**Planning Act 2008: Applicant's Section 51 Response**

**Application ref: EN010147**

**Application by Photovolt Development Partners (PVDP) on behalf of SolarFive Ltd (the Applicant) for a Development Consent Order for Botley West Solar Farm**

Title: **s51 Response - Project Refinements**

### **Project Refinements Plan**

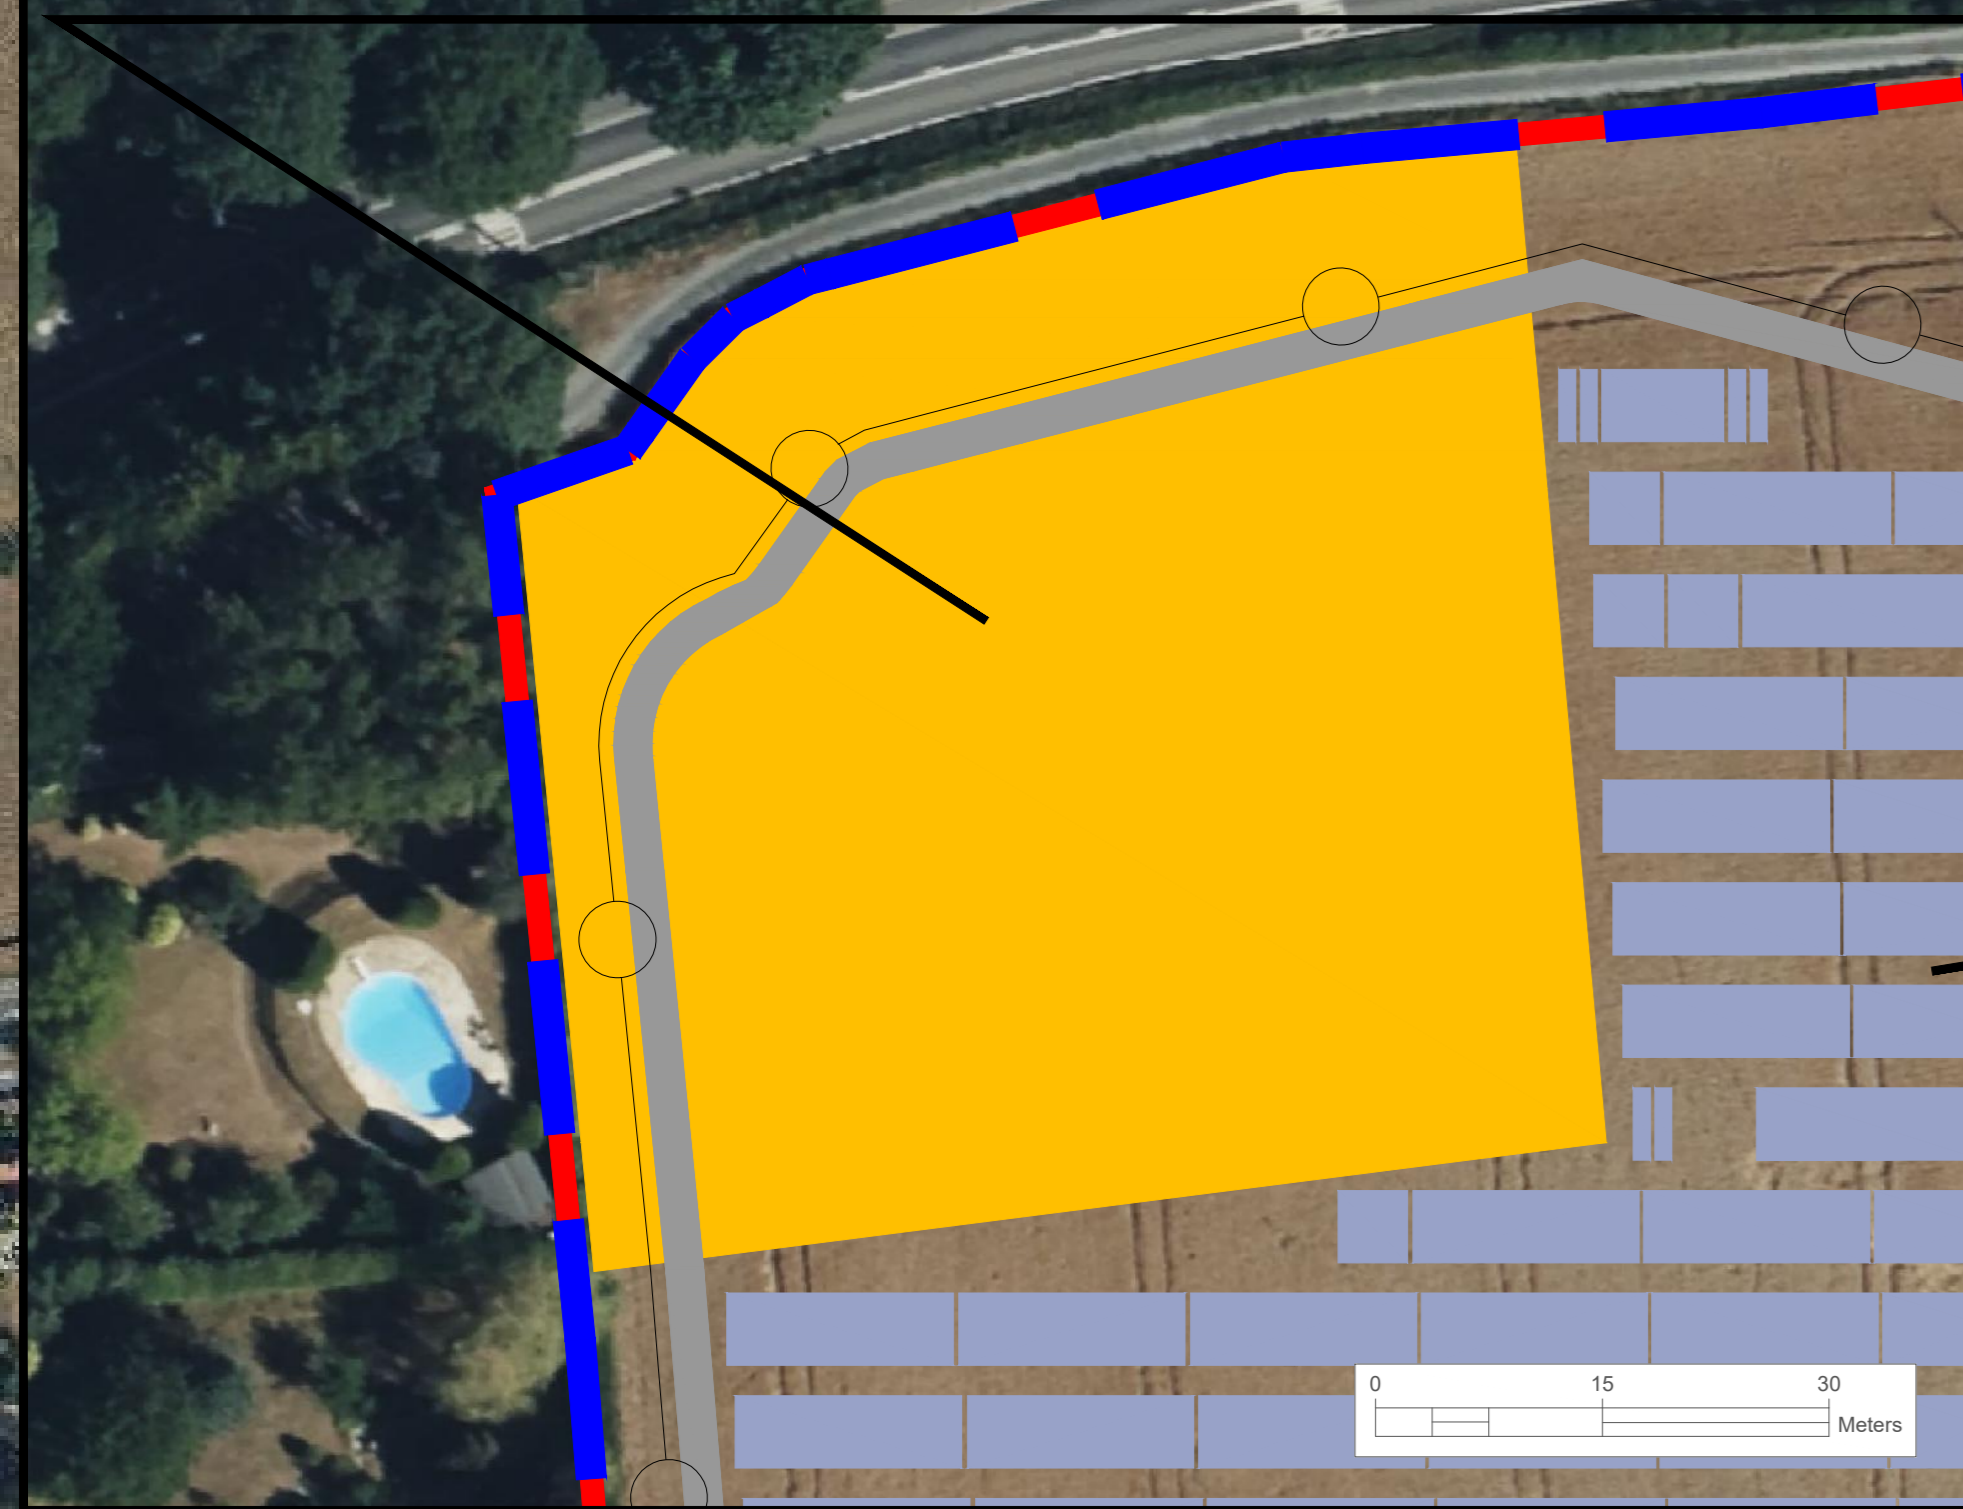
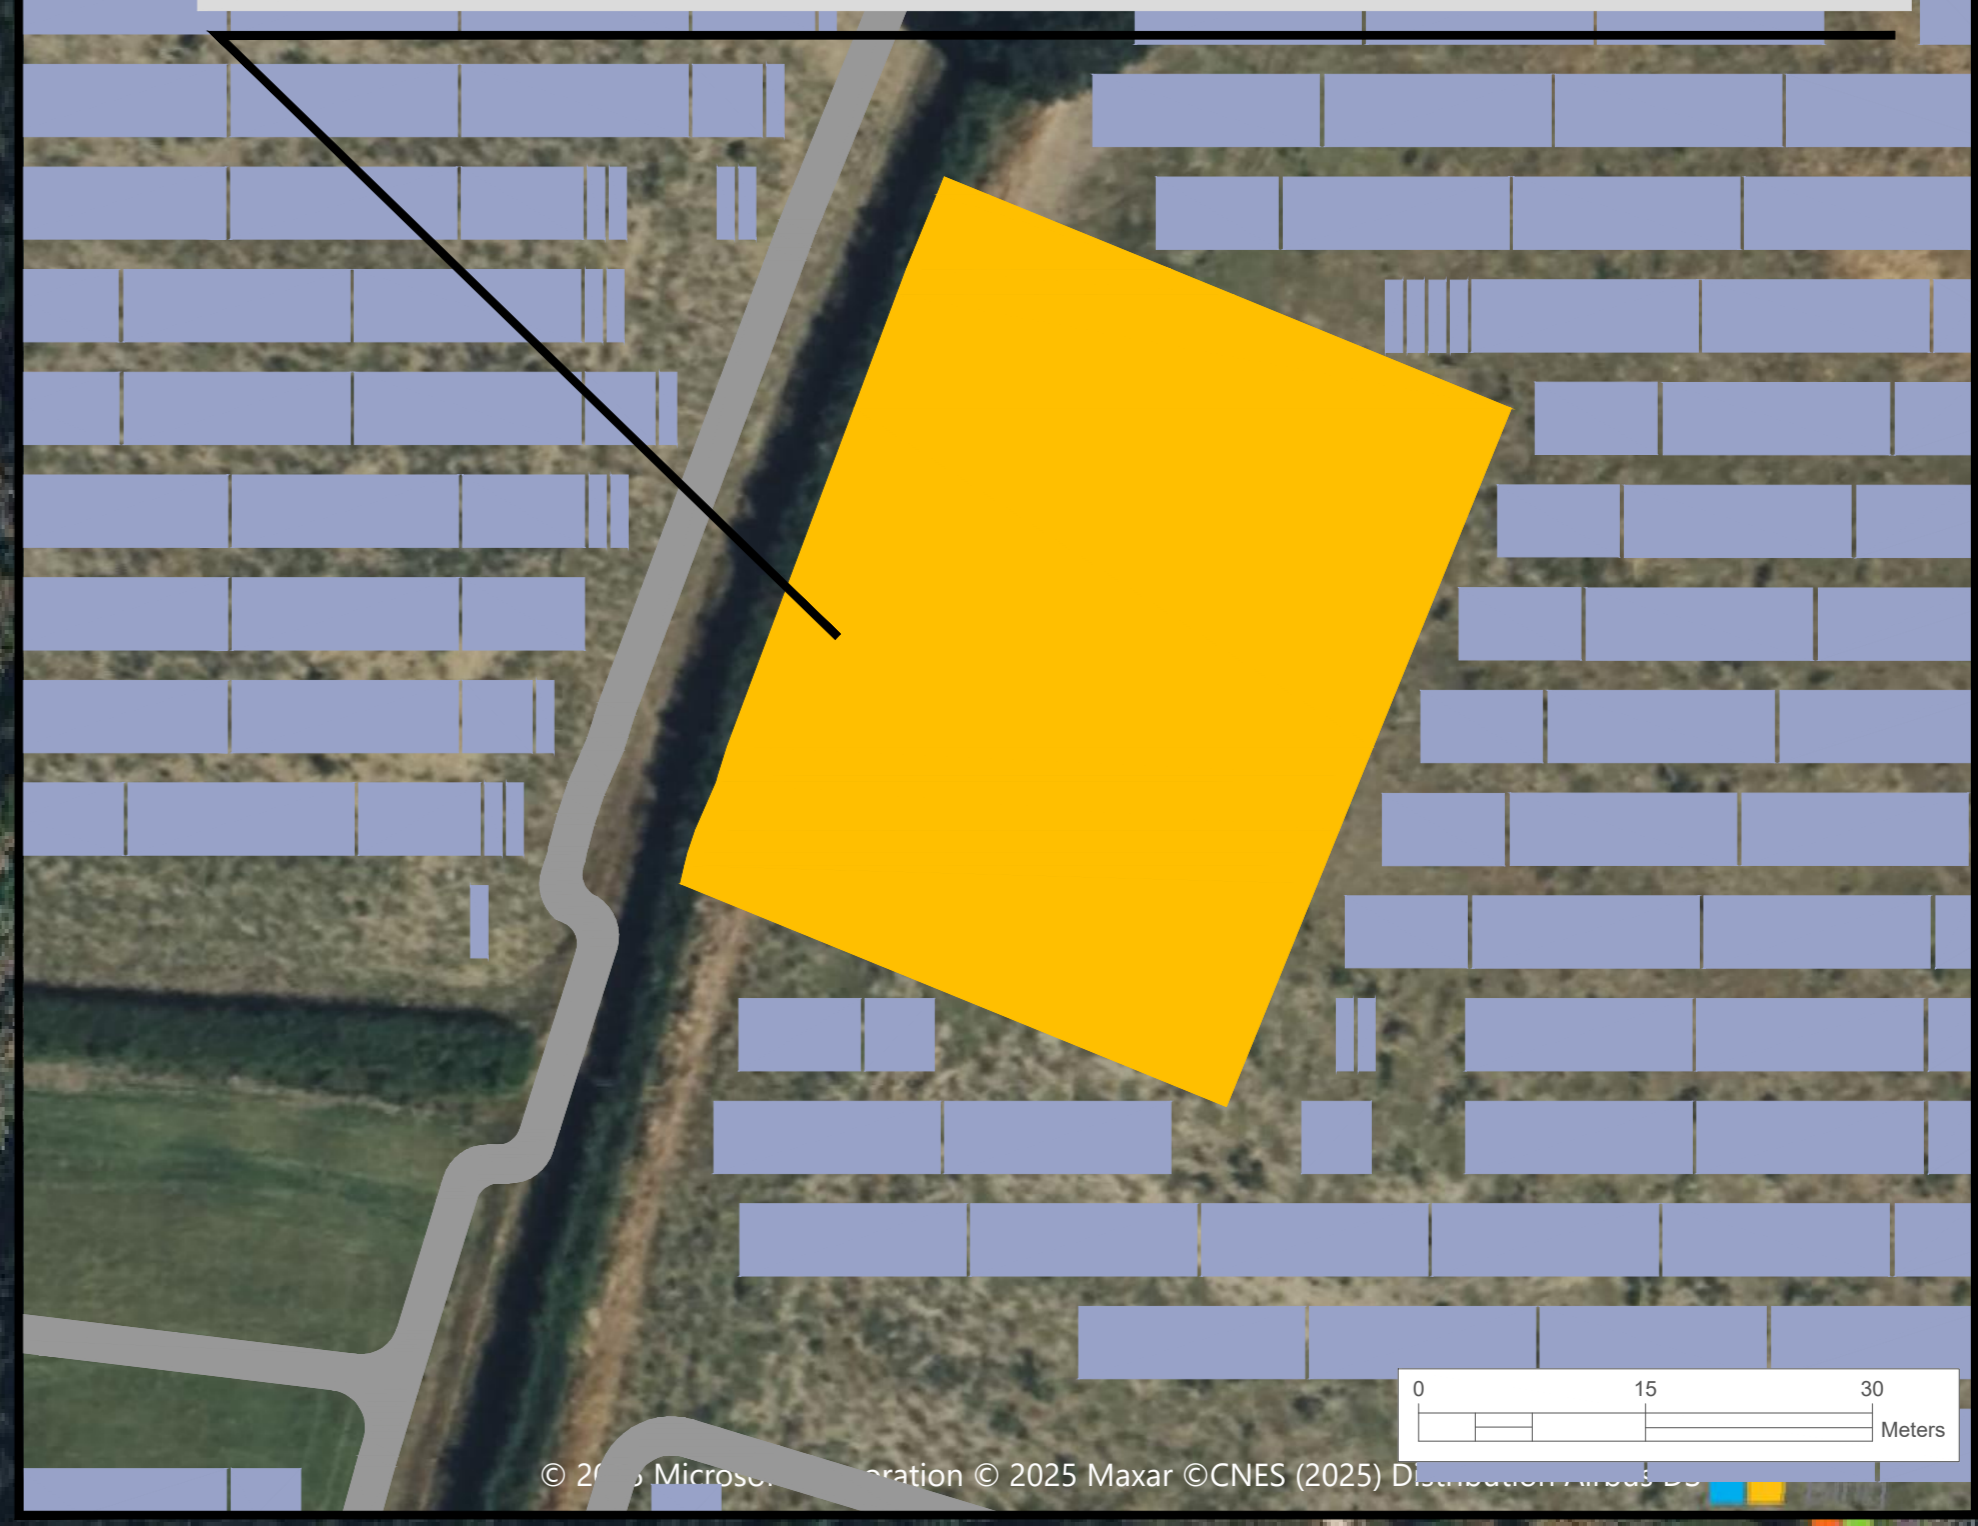
(1) Replace solar installation area for further archeological protection and management (0.30ha)

(3) Small reduction in redline (0.015 ha)

(2) Replace solar installation area for further archeological protection and management (0.17ha)

The Applicant has removed a small area of land (plot 6-17) amounting to 0.015 ha from its redline boundary. The area affected is shown in the ‘Project Refinements Plan’ at Appendix A of this Cover Letter and has also been reflected in each of the new and updated plans submitted alongside this s51 Response. For example, see Sheet 6 of the updated Land Plans and the updated Works Plans.

The reason for the reduction is to remove a vehicular access point that was initially designed to be used for construction and operation, in favour of using an alternative existing vehicular access further south. However, the landowner of plot 6-17 does not wish for the Applicant to use this access point and so, following further landowner engagement, the Applicant is willing to remove this plot from the Project. The Applicant will use the

As shown in the Project Refinements Plan at Appendix A of this Cover Letter, the Applicant has also marginally reduced its area of proposed solar installation in two areas and instead propose to provide archaeological protection and management instead. The first area measures 0.3 ha and the second area measures 0.17 ha only, resulting in a total affected area of 0.47 ha.

This refinement simply extends the approach taken pre-application and is agreed in principle agreed with Mr Richard Oram, the County archaeologist, in order to protect underground archaeology. This alteration has therefore been reflected in the updated Masterplan documents and Works Plans submitted with this s51 Response. Most notably, see Sheet 6 of the Works Plans where the relevant areas have had Work Nos. 1 (solar installation) and Work Nos. 6 (cabling and other miscellaneous works) replaced by Work No. 5 (archaeological protection).
